**Confederated Tribes and Bands  
of the Yakama Nation**

Subject:       Comments on the July 29, 2011, *Draft Report to the Secretary of Energy*, of the  
Blue Ribbon Commission on America's Nuclear Future (BRC)

**Comments on the July 29, 2011, *Draft Report to the Secretary of Energy*, of the Blue Ribbon Commission on America's Nuclear Future (BRC)**

**Prepared by the Institute for Energy and Environmental Research (IEER) on behalf of the Yakama Nation**

Figure 1: Iterative process for repository characterization, including a decision point for continuation or rejection. (Source: IEER 2004 Figure P-1 (p. 10). Translated into English.)

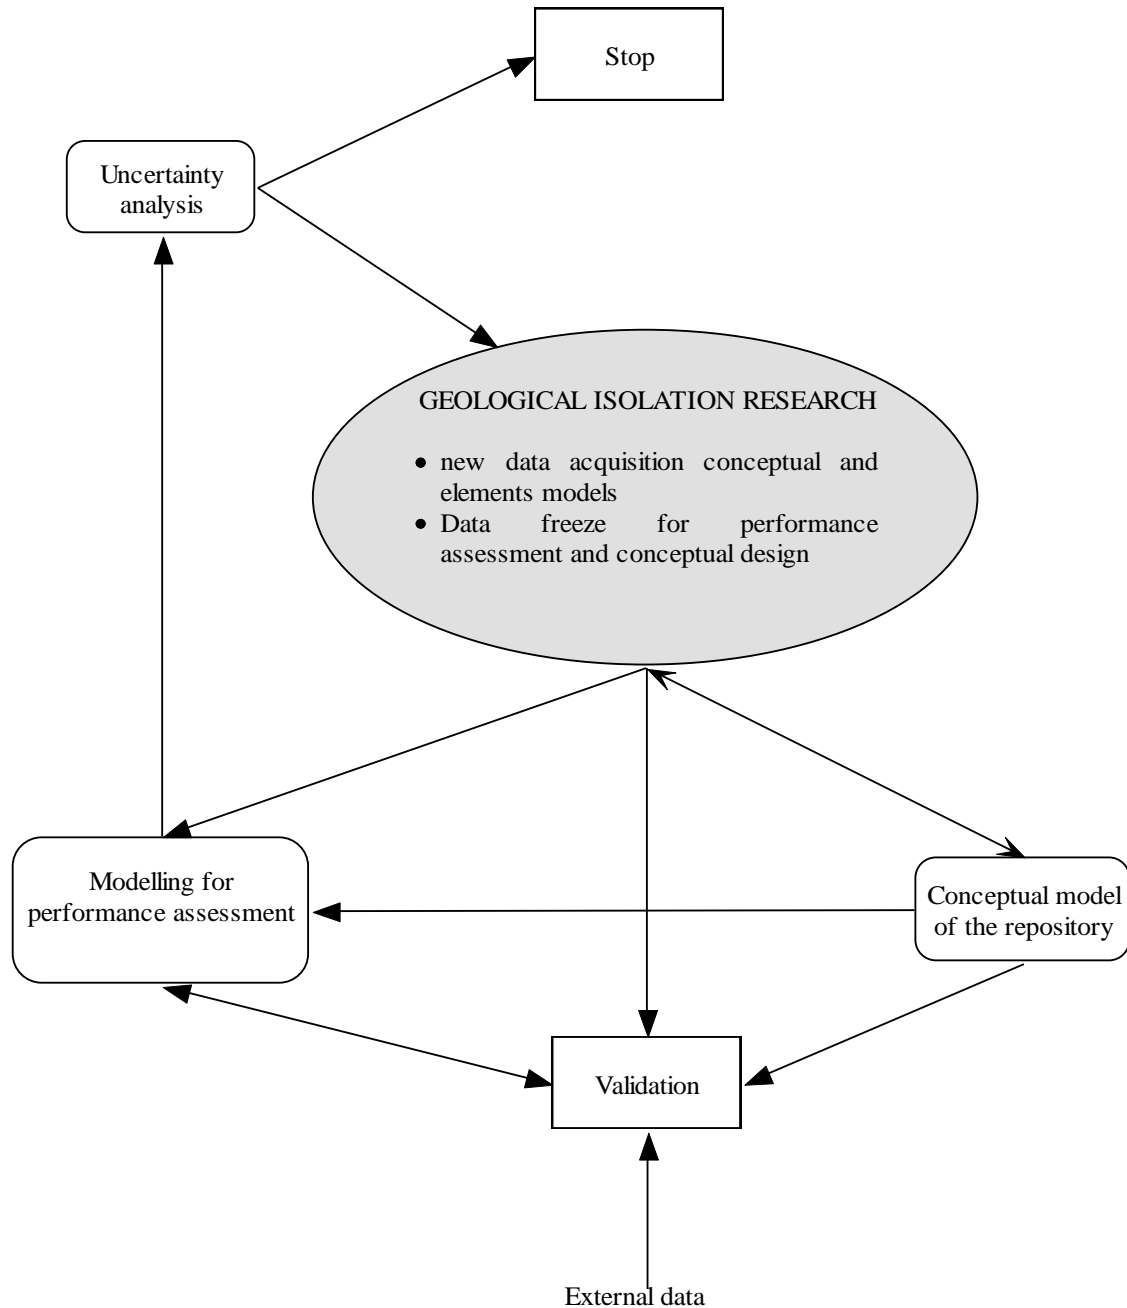
One key point is missing, however. There is no explicit provision for stopping the process and rejecting a site as unsuitable once the characterization process has begun. This is absolutely essential, especially given the technical problems and misjudgments that have afflicted the U.S. site selection process from Lyons, Kansas, to Yucca Mountain, Nevada. A schematic for representing how a site characterization process that would be flexible and incorporate new data and information with integrity and that includes a provision for rejecting a site is shown in Figure 1, which was prepared as part of an evaluation by the U.S.-based Institute for Energy and Environmental Research (IEER), of the research on a French repository site near the village of Bure in northeastern France.<sup>16</sup> Such a provision would come into play if, at a certain point, the range of performance indicators, including uncertainties, indicates that performance is likely to be unacceptable.

An iterative process like that in Figure 1 satisfies the flexibility and adaptability criteria recommended by the BRC, but it puts them in a specific scientific context that is essential for the integrity of the process. For instance, the Hanford process should have stopped in 1983, when Dr. Donald White prepared the paper quoted above, unless it could be independently shown to be definitively wrong with information available at that time. Of course, if the characterization process does not meet such an end, then the process continues. At some point, a suitable amount of on-site and other research as well as performance modeling will provide enough confidence to proceed beyond characterization to repository development.

**Figure 1: IEER's modeling results for trench disposal of GTCC and GTCC-like waste in a trench at Hanford**

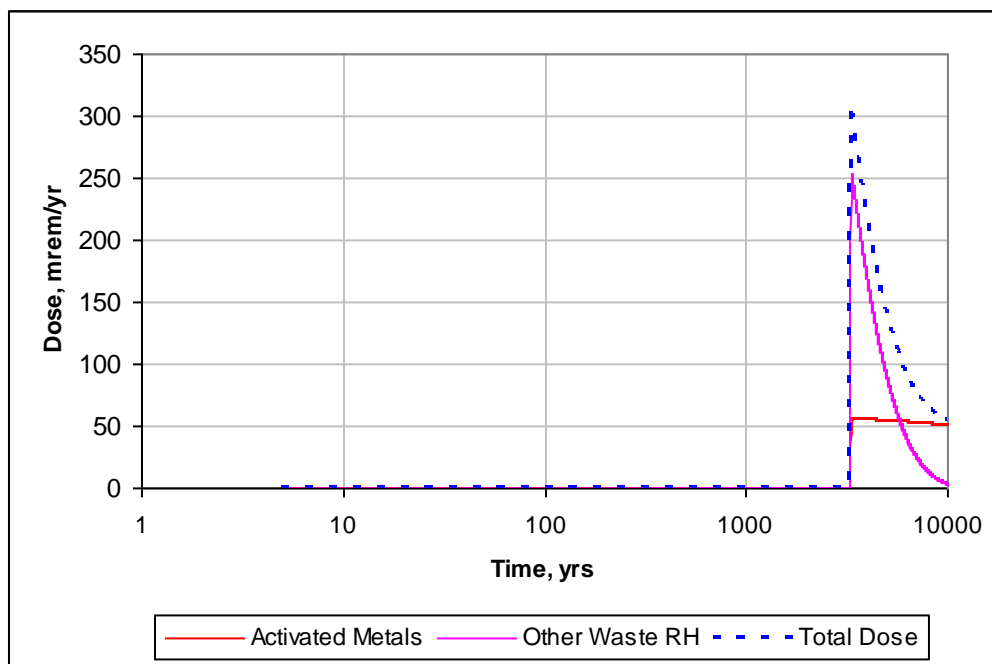
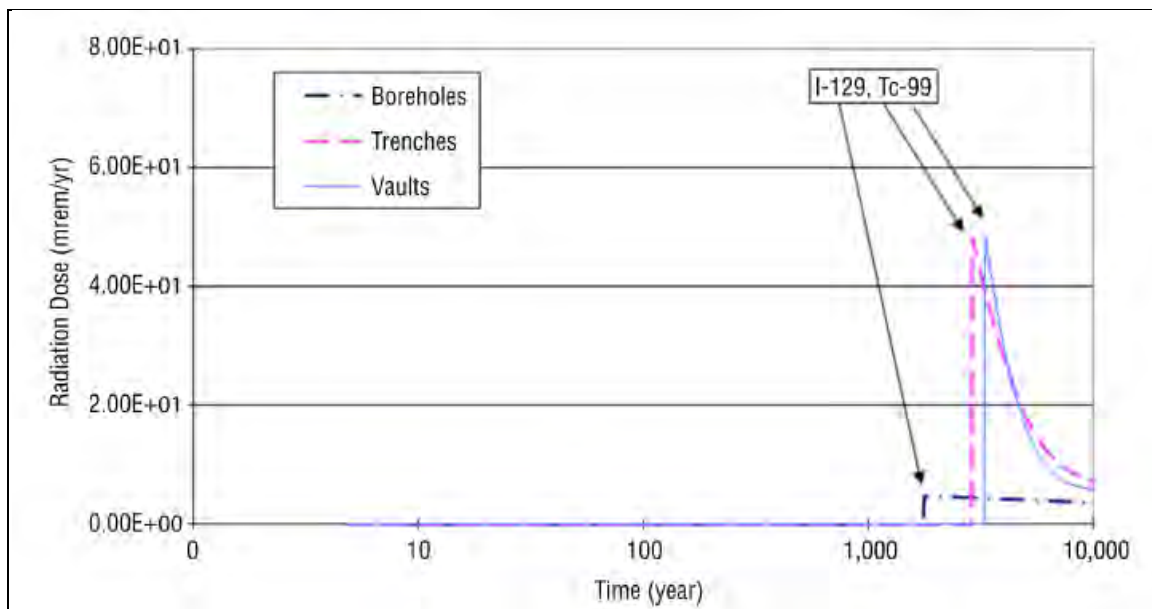
Figure 1 shows the results of IEER's verification calculations using the DOE assumptions so far as we could determine them from the Draft EIS (see Appendix A for more details).

As can be seen from Figure 1, IEER's peak dose estimate using the DOE's parameters so far as they could be determined is about 300 millirem per year. The activated metals dose is about 50 millirem and the Other Waste - RH dose is about 250 millirem. The total peak dose is about six times the DOE's estimate of 48 millirem noted above. Figure 2 below shows the results of DOE's trench disposal modeling in more detail.

**Figure 3: Total Dose for the Different Distances to the Well** (Note: Base case distance to the well is 300 m, which is in between the case of very close (25 m) to the site boundary and 600 m).

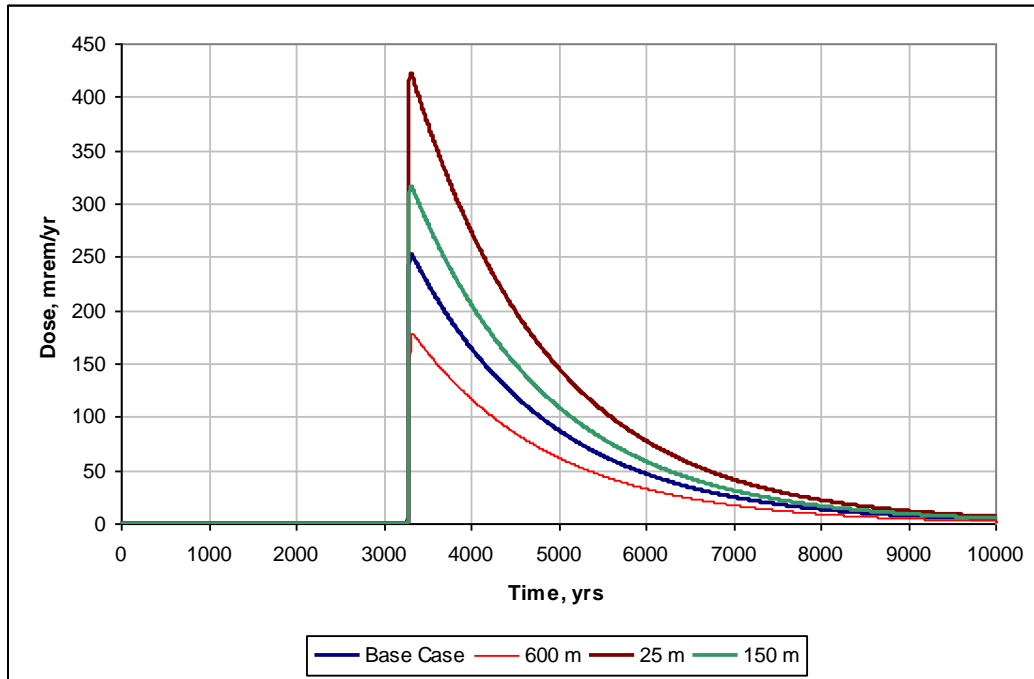
It is clear that the variation of a single parameter increases the dose from the most important component of the waste in terms of peak dose (Other Waste - RH) from about 250 mrem/year to over 400 mrem per year.

**Figure 4: Base Case and Conservative Case for the Other Waste - RH category.** (Note: The green line represents the total of activated metals and Other Waste - RH. The red line is Other Waste - RH alone)

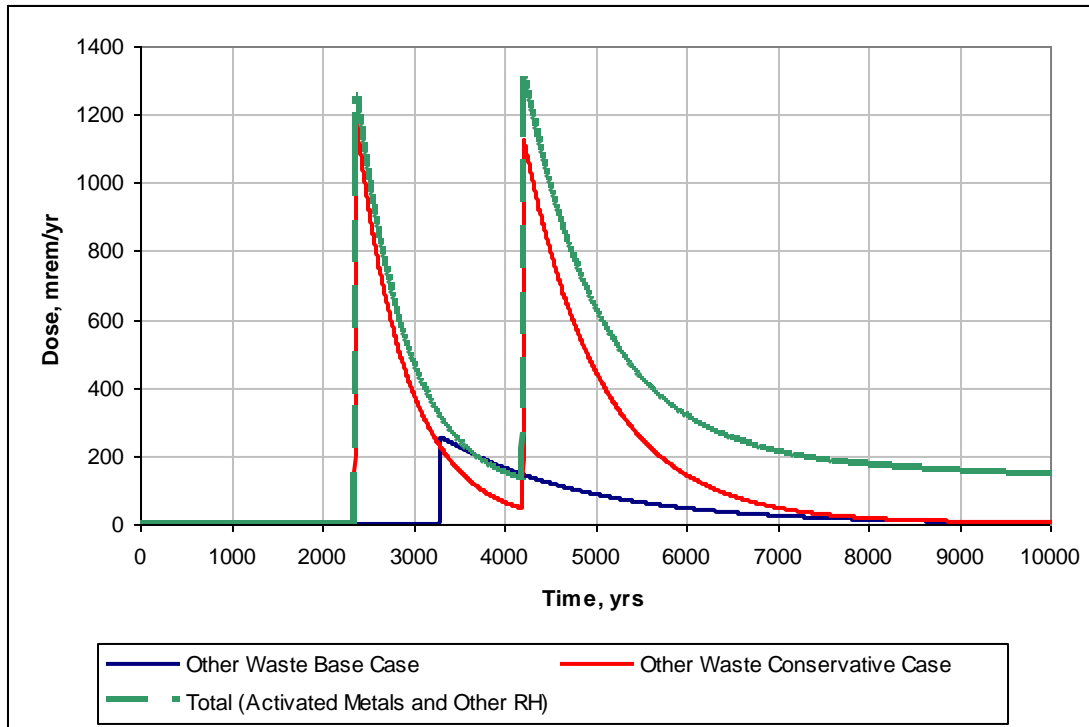
When all parameters are varied the upper limit of dose increases by about a factor of four for total dose and by more than a factor of four for the Other Waste - RH category. See Figure 4 below and Appendix A for more details.

**Figure 5. Base Case and Cover Erosion and Aquatic Food Scenario for the Other Waste RH Category (red line). The green line shows dose for the total source term (other waste plus activated metals)**

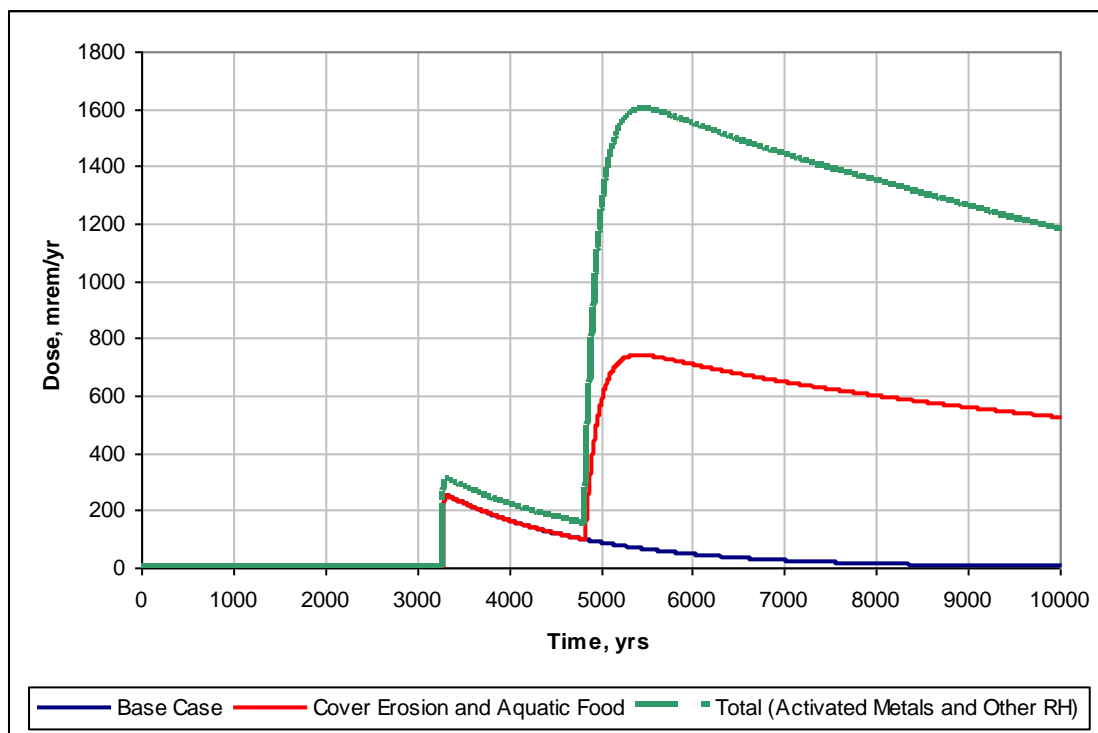
An erosion rate of 1 mm/year results in the 5-meter thick trench cover being completely eroded in 5,000 years. Hence, at that point, rain and snow contact the waste, some of which gets washed off into surface water. This means that the dose from the aquatic food pathway is significantly increased. Figure 5 shows the results for the cover erosion scenario. The red line shows the dose from Other Waste RH and the green line shows the total dose. Note that even though the other parameters, such as infiltration have been maintained the same as in the base case IEER model, there is a second peak dose, after the cover erodes, of about 1,600 mrem/year at somewhat over 5,000 years after disposal;

this is much greater than the first peak, which occurs due to groundwater use. The main reason for the higher second peak is the dose from consuming surface water and aquatic food from surface water sources.

Further, the major contributors to the second peak are the transuranic radionuclides Cm-245, Pu-239, and Pu-240. This is completely different from the Tc-99 and I-129 doses, which are important in the earlier peak.

**Figure 6: Borehole Land Disposal Alternative for the Group 1 Stored Other Waste - RH Category**

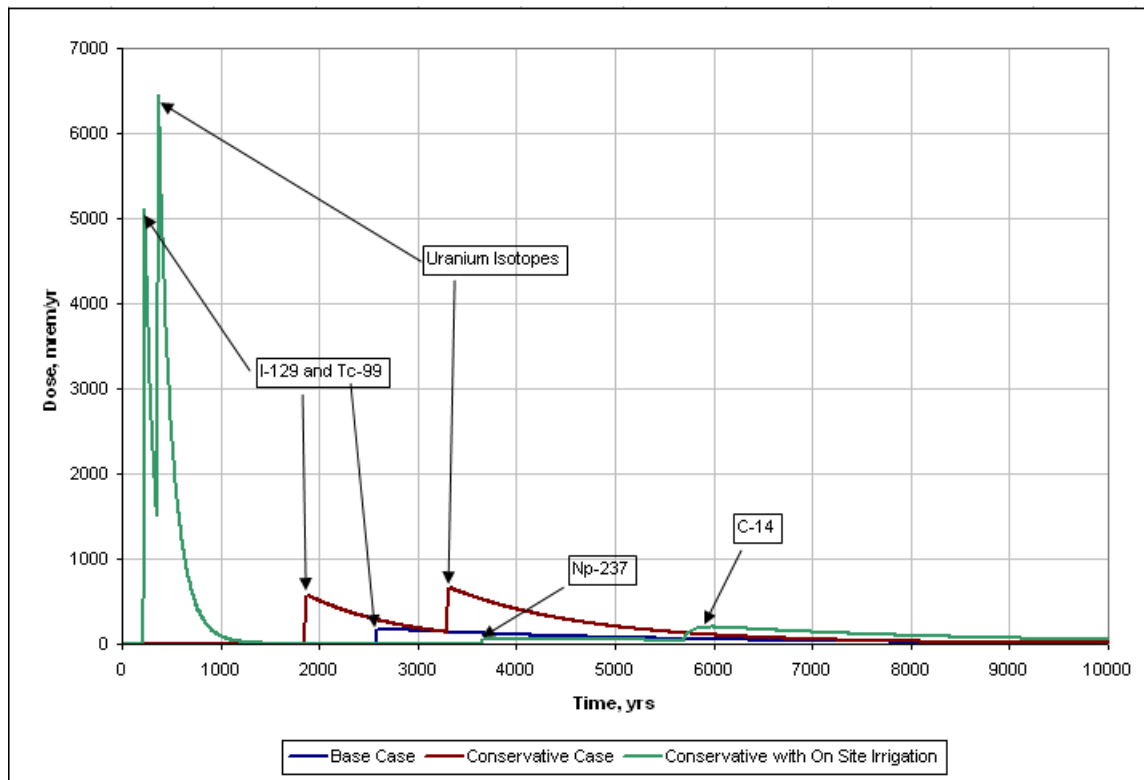
case of using irrigation from the site had two peaks – one of 5,050 mrem/year 235 years in the future due to I-129 and Tc-99 and one at 6,431 mrem/year 372 years into the future due to uranium isotopes. For context, the Draft EIS’s estimate of peak dose due to borehole disposal was just 4.8 mrem/year – 37 times lower than the lowest borehole estimate when institutional controls are relaxed and more than 1,300 times lower when there is total loss of institutional control and memory.

Note that the highest dose in the irrigation scenario case is due to uranium – a strong reminder that large amounts of uranium are unsuitable for disposal even in boreholes as much as 40 m deep. So long as the disposal is relatively shallow and water is available beneath the disposal, the method is likely to be a problem from the point of view of a resident farmer and loss of institutional control.

**Figure 1. Exposure Pathways Associated with the Use of Contaminated Groundwater**

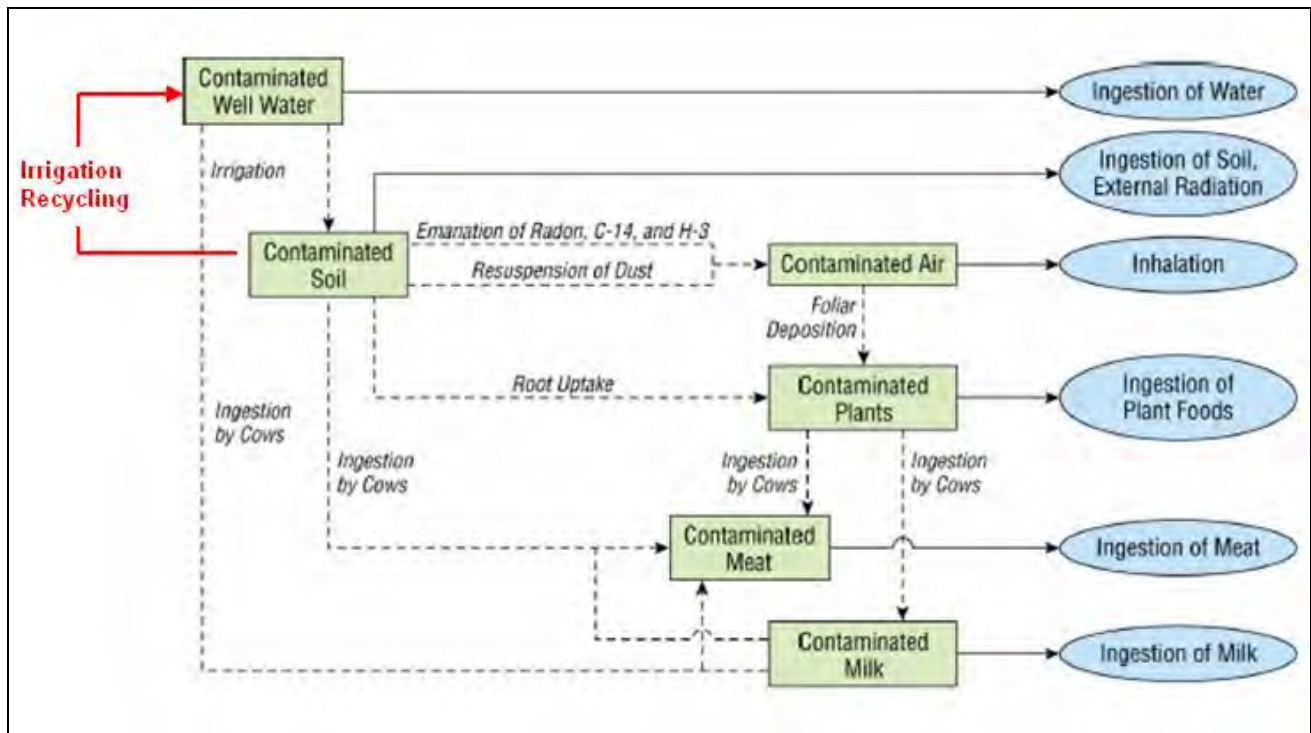
The exposure pathways associated with the use of contaminated groundwater implemented in RESRAD-OFFSITE are shown in Figure 1. The red arrow is added to the original figure presented in the draft EIS to demonstrate the missing link (irrigation recycling) between the contaminated offsite soil and the groundwater.

NOTE: This figure was reproduced from Figure E-2 (v. 2, p. E-9) in draft GTCC EIS. The red arrow and text box were added to the original figure.
